Northrop Research and
Technology Center

9 May 1986

Dr. Herbert N. Berkow, Director
Standardization and Special
Projects Directorate
Division of PWR Licensing-B, NRR
U.S. Nuclear Regulatory Commission
Washington, DC 20555

SECTION I

Figure 1

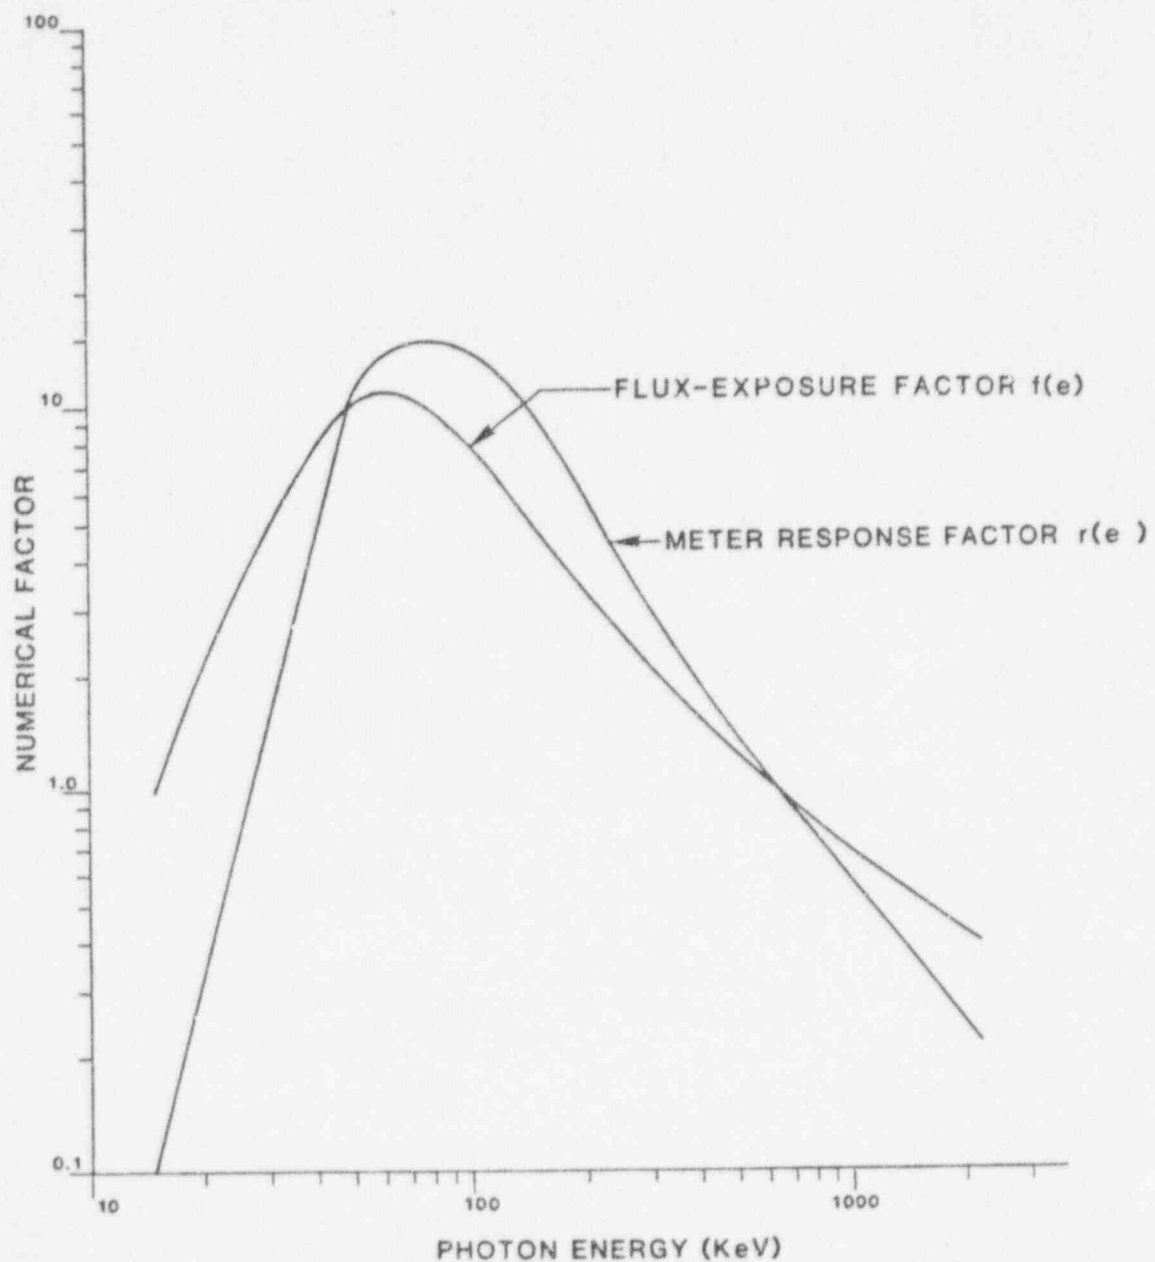
- (1) Radiation measurements were obtained by Northrop Corporation using a sodium iodide crystal which is calibrated for a certain source type and strength. The methods and standards used for calibration of this survey instrument were not specified in the final report. Please provide a detailed description of your calibration procedure and justify use of a scintillation detector, which is an energy dependent instrument, to measure dose rate with reasonable accuracy (e.g. $\pm 20\%$) over the wide range of energies expected in your surveys.

The factor $r(e)$ is plotted as a function of photon energy in Figure 1 (ref.2)

where the function $f(e)$, flux-exposure factor, is plotted in Figure 1, and normalized to 1 for the Cesium gamma ray. Using this expression the values for exposure associated with each of the photon groups were calculated in Table V, column (7). Finally, using Equation (3) the meter readings corresponding to these exposures were calculated and listed in column (8). Summing the meter readings from each energy group

Figure 5a

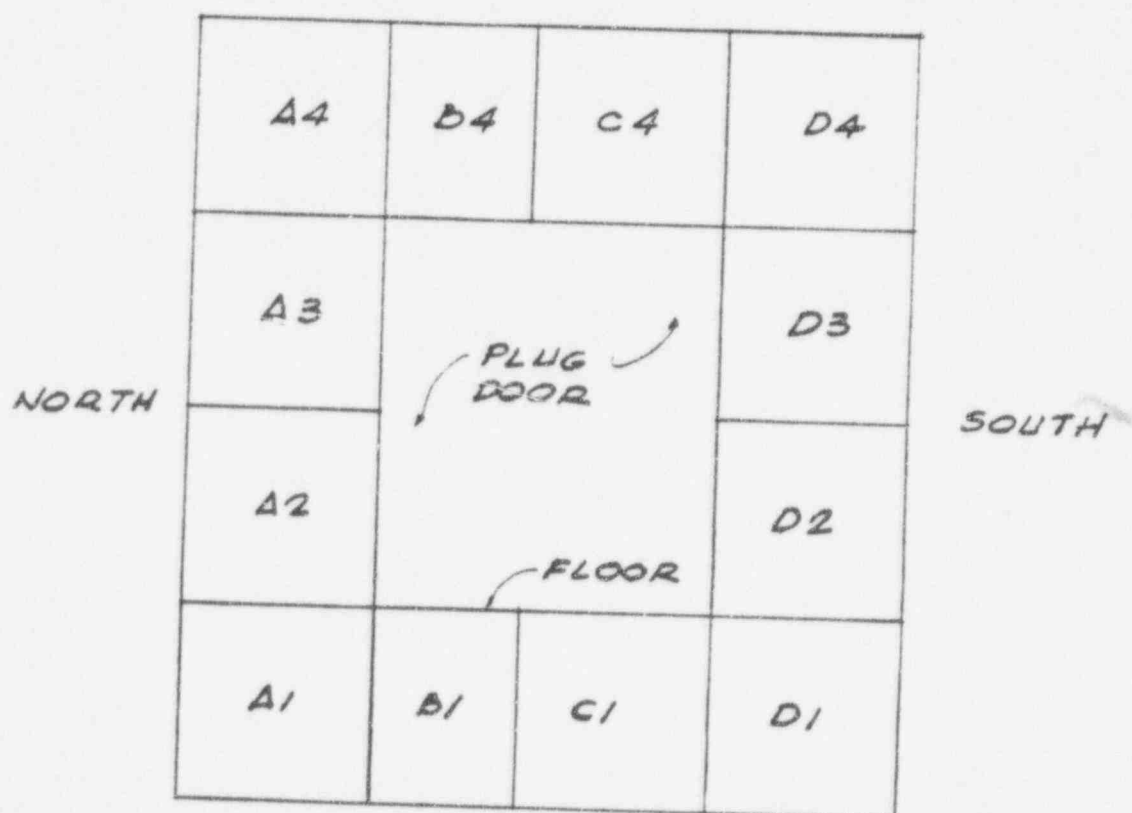
- (2) Your report indicates that your survey of the Exposure room was hampered by the small dimensions of the room, which resulted in your providing 4 pi readings versus measurements which would directly demonstrate satisfaction of the requirements of 5 uR/hr, at one meter from any planar surface. Your calculations indicated that the readings were close to background. However, because of the geometry problem, you dismantled the room and placed the resulting biological shield concrete rubble in a pile. Your survey of this pile also indicated readings close to background. However, during its final survey of your facility, the Region V staff found that the configuration of the concrete rubble pile precluded their obtaining the required final survey measurements with the available instrumentation.

Accordingly, we request that Northrop Corporation: (a) provide all the readings that were taken of the Exposure Room walls prior to dismantling, with and without shielding, (b) discuss the method used to determine "background" radiation and provide the respective data, (c) show from your measurement techniques and data that the contribution of dose rate from the surrounding walls could be subtracted from the relevant planar wall to provide the "close-to-background" dose rate from the planar wall, (d) physically redistribute the concrete rubble pile into a homogeneous configuration with as uniform and even a surface as possible and not more than about 1 foot deep. Measure the radioactive contamination levels at the surface and the radiation levels at one meter from the surface at a suitable number of locations.

Since the exposure room was classified as a "high potential" area the walls, floor, and ceiling were marked off in one-meter grids and 75% of the squares were selected for measurement by means of a random number generator. Figures 5a-e show schematic representations of the manner in which all surfaces were sectioned for the survey. Data on the west wall is missing because this is the wall which is shared by the pool and it was essentially eliminated when the window was removed.
